MILITARY SPECIFICATION

REPRODUCER, SIGNAL DATA: AN/GSQ-64
(READER, PUNCHED TAPE)

This amendment forms a part of Military Specification MIL-R-46332A(MU), dated 10 March 1965.

FIGURE 2

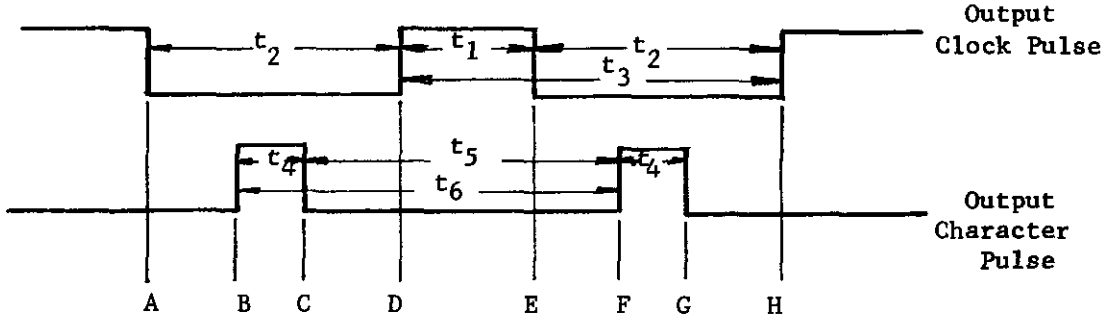
* Paragraph 3.6.1: Change third, fourth, fifth, sixth and seventh sentences as follows:

"Pulse duration for t1 + t2 shall be 2.25 msec ± 10%. The normal pulse duration for t5 shall be 1.54 ± .07 msec. At temperature extremes, the pulse duration for t5 shall be $1.54 \pm .\frac{1}{3}$ msec." Fourth sentence: Delete

"between the minimum and maximum values specified in Table II for the appropriate ambient temperature", and substitute "more negative than -5.5 volts". Fifth and sixth sentences: Change "5,600 ohm"to "600 ohm". Seventh sentence: Change "The peak amplitude of the positive going pulse" to "The peak amplitude of the negative going pulse".
